Midland Railway Workshops site, Helena East Precinct: Review of reports relating to hydrogeology of the site and potential impacts of groundwater contaminants on the Helena River.

**Report to ATA Environmental for Midland Redevelopment Authority
by Crisalis International Pty Ltd**

June 2005

Review and Recommendation on Groundwater Monitoring at Helena East Precinct, Midland Railway Workshops: Report to ATA Environmental for Midland Redevelopment Authority.

FIGURE 2

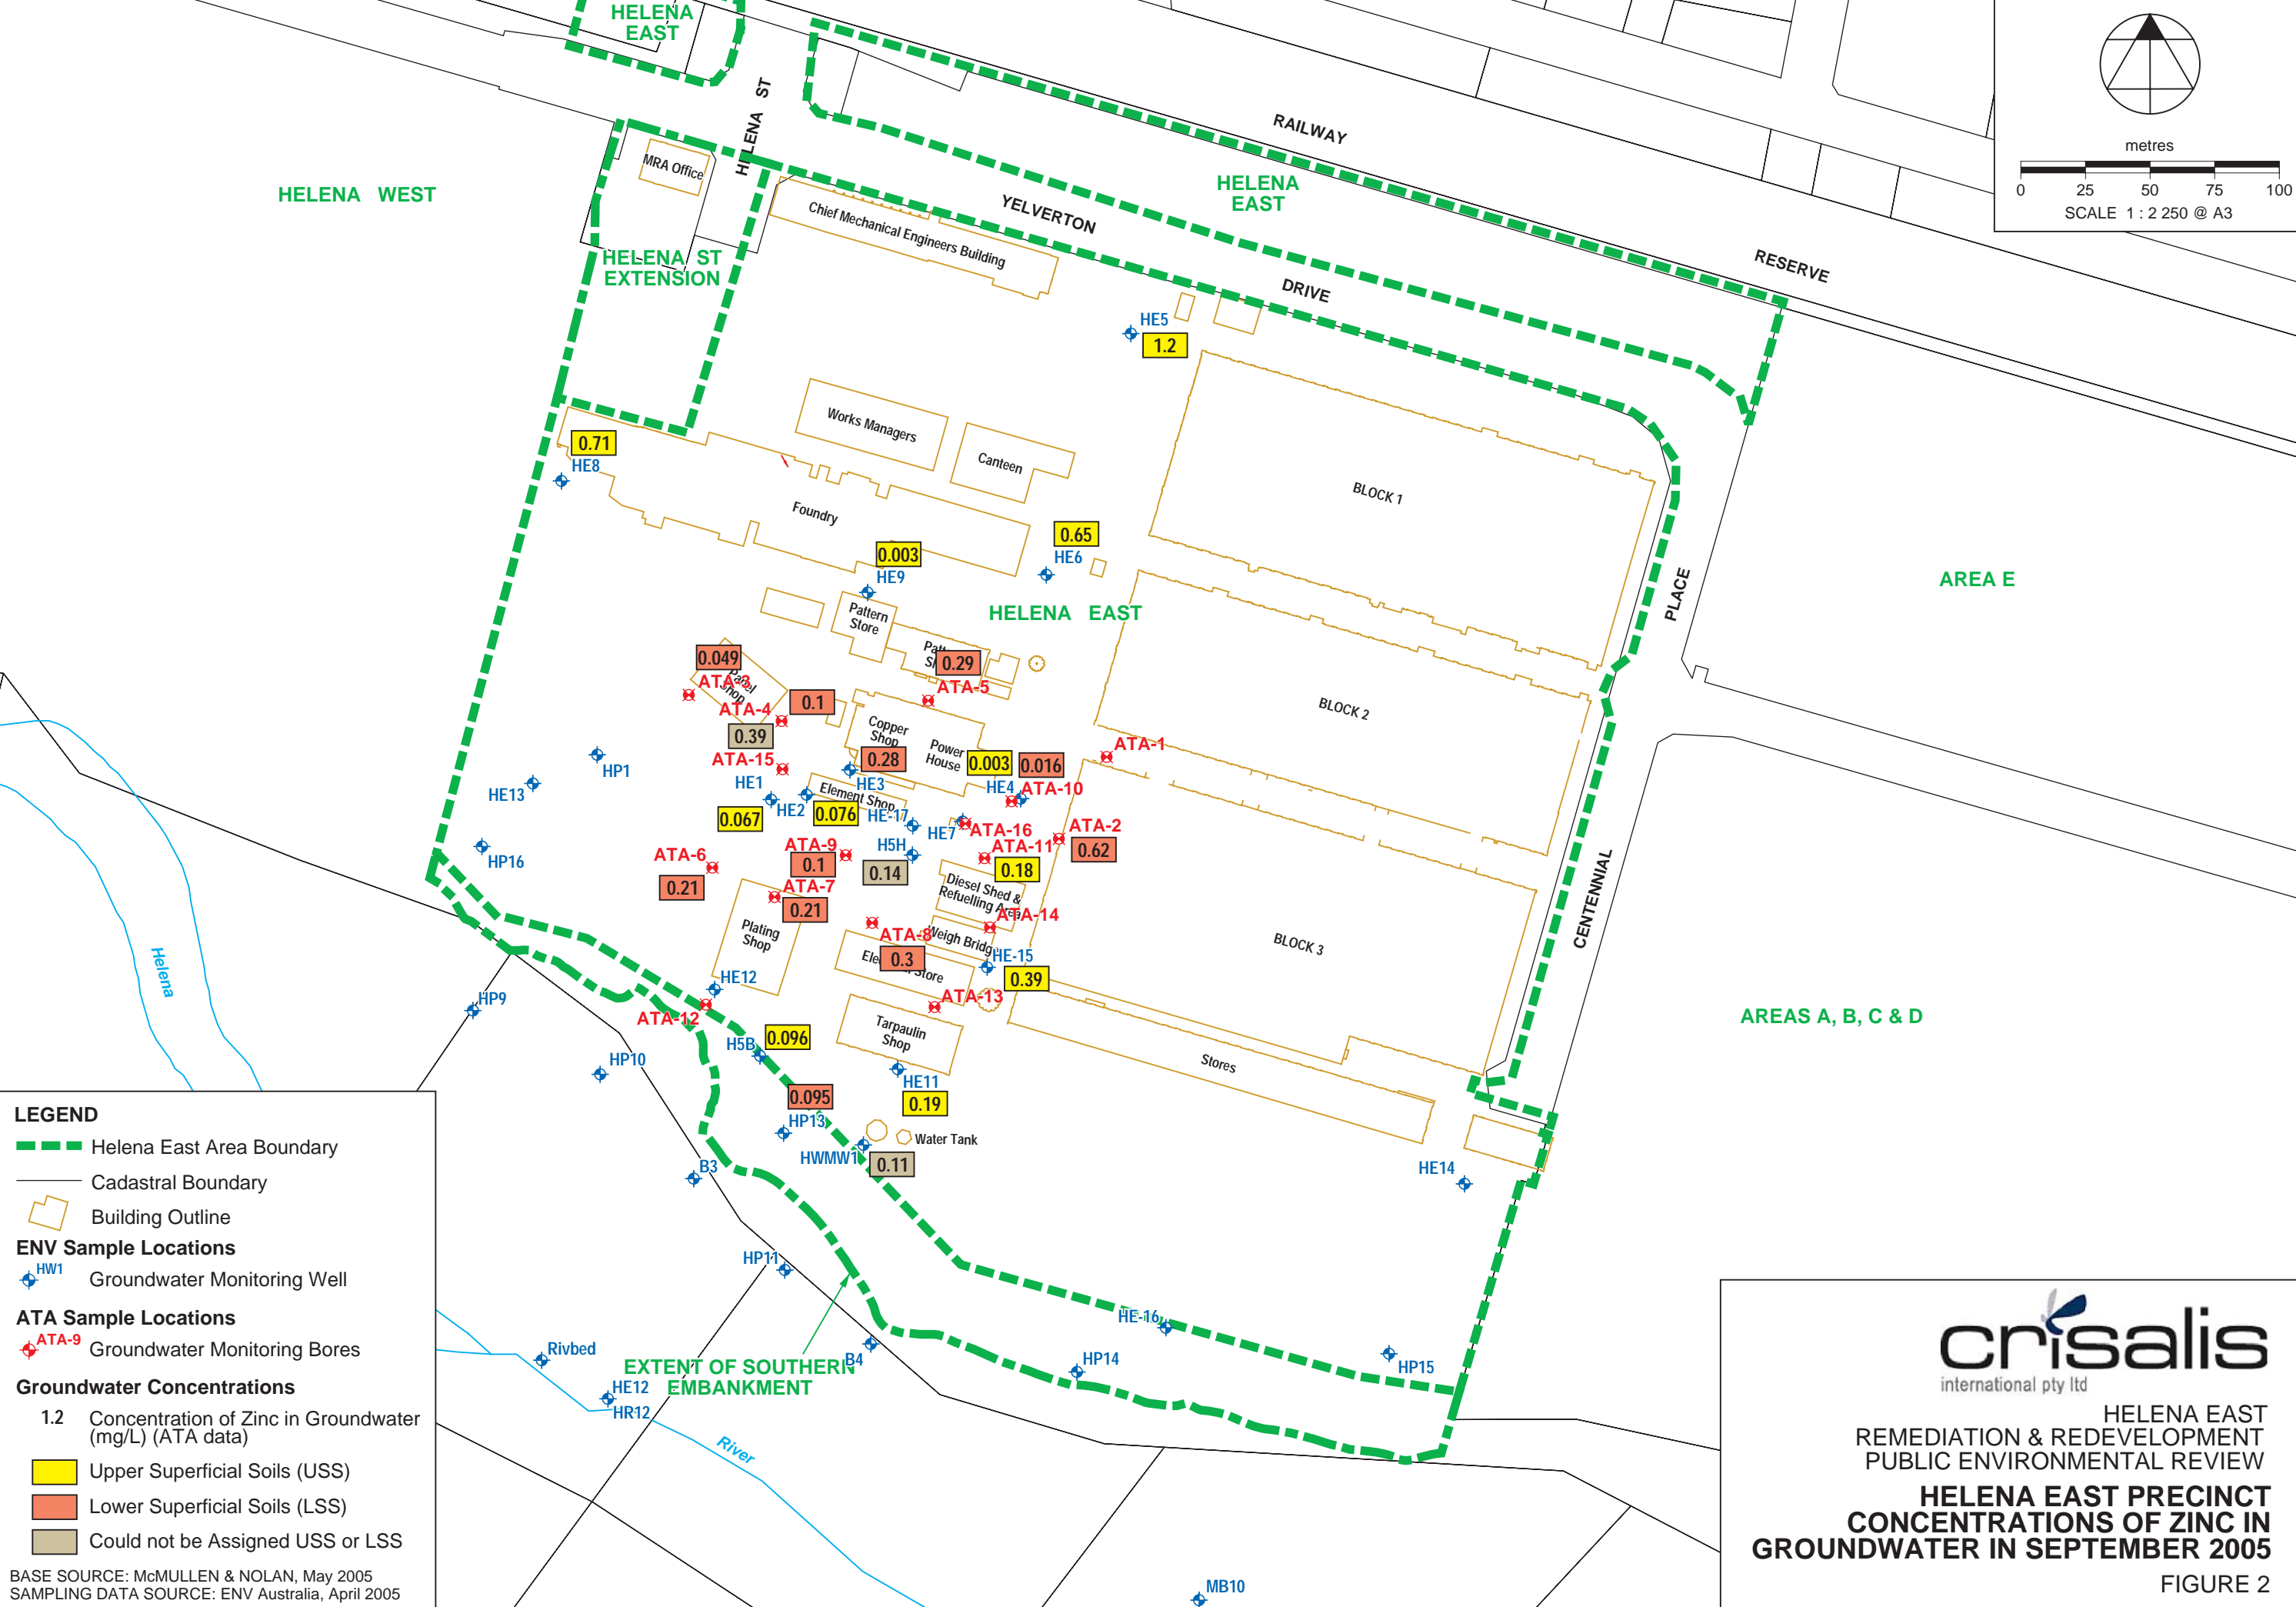
Groundwater concentrations exceeding freshwater criteria for zinc particularly, and a much lesser extent for nickel, are apparent in Figure 10a in the PER (ATA, 2006) and summarized here in Figure 2. These are mostly associated with the main area of contaminated soil, with multiple sources such as the Copper shop, Plating shop etc within the central southern region of the site. There is some possible contamination associated with the Foundry (bores HE6 and HE8 only) but little apparent contamination with other “source” areas. Bore HE5 in the central northern region of Helena East shows the highest groundwater concentrations of lead and copper.

There is little obvious trend in concentration of zinc in groundwater in bores in Figure 2 associated with the SSA or the LSA. Bores in the SSA within the main contaminated area vary from 0.003 mg/L (ATA-1) to 0.65mg/L (HE6). The only shallow bore on the southern boundary of the area (HP13), closest to the Helena River shows zinc at 0.095mg/L, approximately an order of magnitude above freshwater criteria of 0.008mg/L (8µg/L).

Groundwater in deeper bores in the LSA in Figure 2 show zinc concentrations ranging from 0.093mg/L (ATA15) to 1.2mg/L (bore HE5). Deeper bores on the southern edge of Helena East are generally above the freshwater criteria (up to 0.19mg/L in bore HE11).

Mean concentrations of zinc in groundwater in the SSA (0.2mg/L; 16 bores) are surprisingly less than those in the LSA (0.41mg/L). The highest zinc concentration in 2005 data is also found in the LSA on the northern area of the site (bore HE5) adjacent to the site office and not associated with any obvious contaminant source apart from the roadway.

Given that most groundwater samples obtained from Helena East were above the Freshwater criteria level for zinc of 8 µg/l (0.008 mg/L), and much higher than the possible background concentrations observed in Helena West and in Areas B, C, D and E (18-68µg/l and 6-22µg/l respectively for these sites), it is recommended that the bores sampled in September 2005 continue to be sampled in future. There does not seem to be any compelling reason to increase the level of sampling (at least for metals) through emplacement of additional bores.
